Benton County Planning Board

**REVISIONS TO AN APPROVED SITE PLAN
PLANNER'S TECHNICAL REPORT**

15704 East Hwy 12, Rogers, AR 72756

REVISED OVERALL SITE PLAN –December 12, 2013

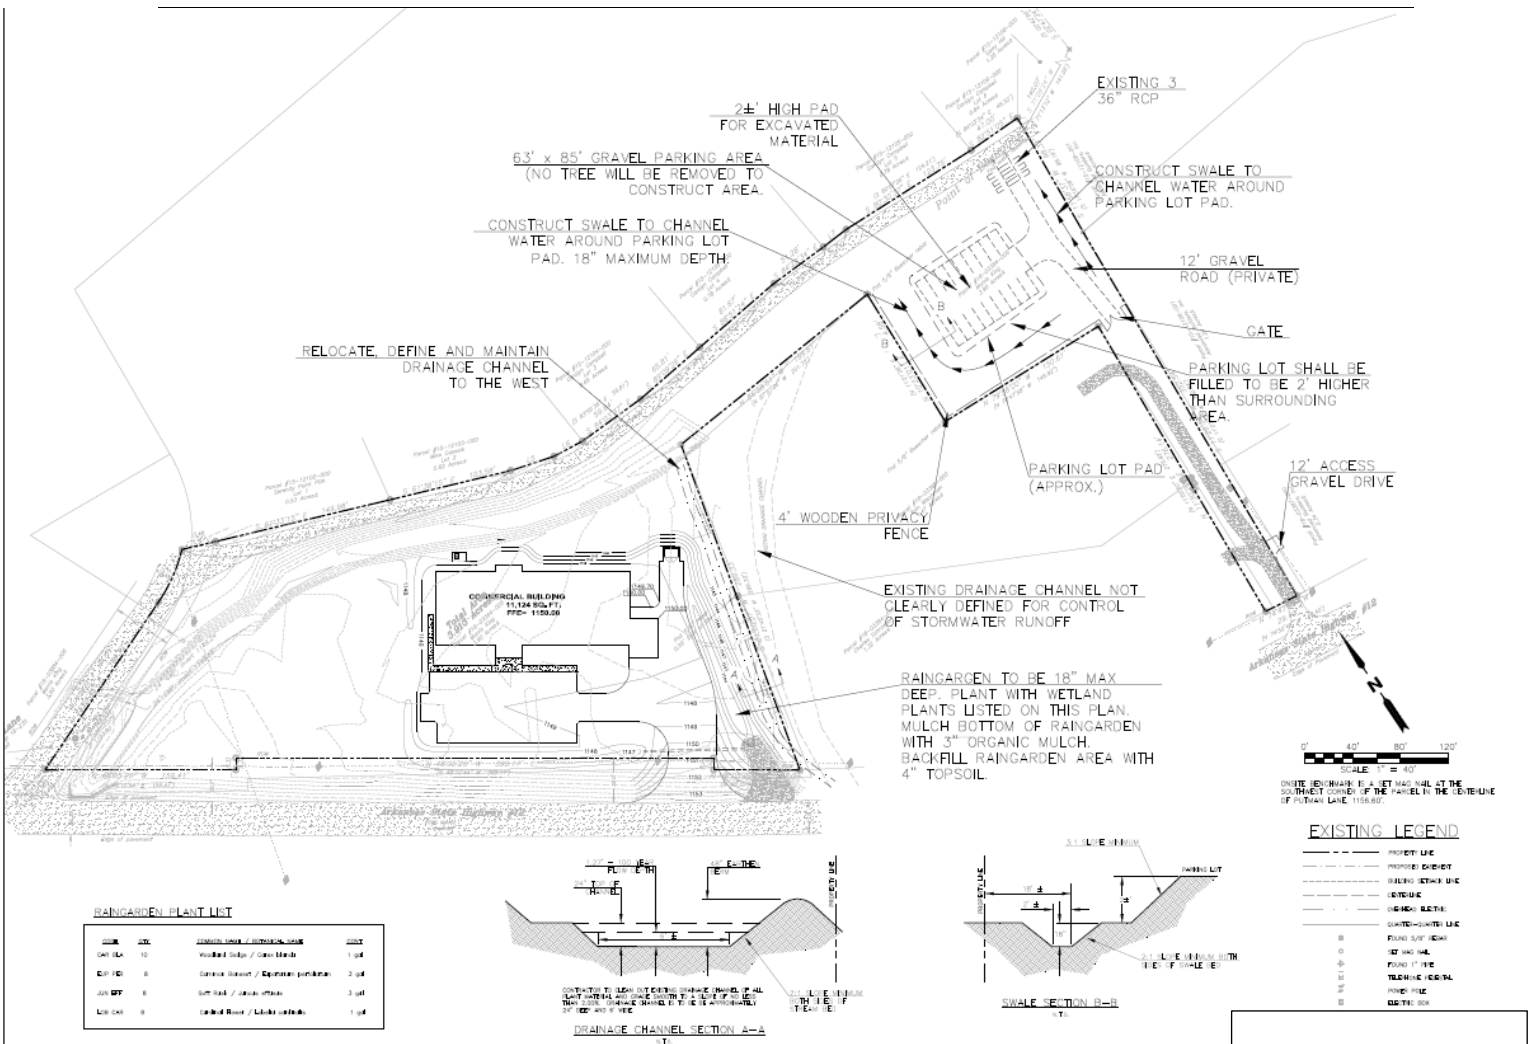
- Staff has concerns that the cross section indicates the building pad to be higher than the adjacent property to the east; this will cause flooding on the adjacent property. Staff requires that the applicant include existing and proposed grades on the cross section and verify the measures for protection of the adjoining property during a flood event. Provision of a berm may be necessary to prevent flooding. The "as built" elevation of the building is also required to be confirmed.

- Provision of rain garden will help in improving the quality of runoff from the parking/loading area. A cross section of the rain garden and Maintenance schedule is required to be included.

- Applicant is required to confirm if the employee parking will be raised 2 feet or 3 feet above the grade. The cross section indicates 3 feet while the text on the site plan indicates 2 feet elevation above the adjacent grade.

- Applicant indicates that an 18" deep and 2 feet wide swale will be provided at the perimeter of the raised parking area. Based on a review of the overall topography of the area, it is evident that the land is relatively flat and has been subject of flooding in the past. Raising the employee parking area may negatively impact the adjacent property accommodating a house to the south.

Staff remains concerned with the proposal to raise the employee parking located on the north-east part of the subject land, close to Bear Creek, above the existing grade. Based on numerous site visits conducted during dry and wet weather conditions staff has witnessed the water flow on site. Considering that this area receives water from the surrounding area and facilitates its release to abutting Bear Creek, any grade change may cause potential negative impact to the property to the south.

Comment: in accordance with the letter dated December 12, 2013, the applicant provided channel analysis including a 24" berm on east side of channel to protect the adjacent property. The requested addition of existing and proposed grades have not been added to the cross sections.

Comment: The revised site plan and cross section submitted on December 12, 2013, indicates that the employee parking will be raised 2 feet higher than the surrounding area.

Comment: in accordance with the letter dated December 12, 2013, the applicant noted that, "materials placed on the proposed parking area per plan will be removed from the drainage channel therefore no net increase in flood storage area will be incurred. Staff is unclear as the gravel removed from Bear Creek should be removed from the site.
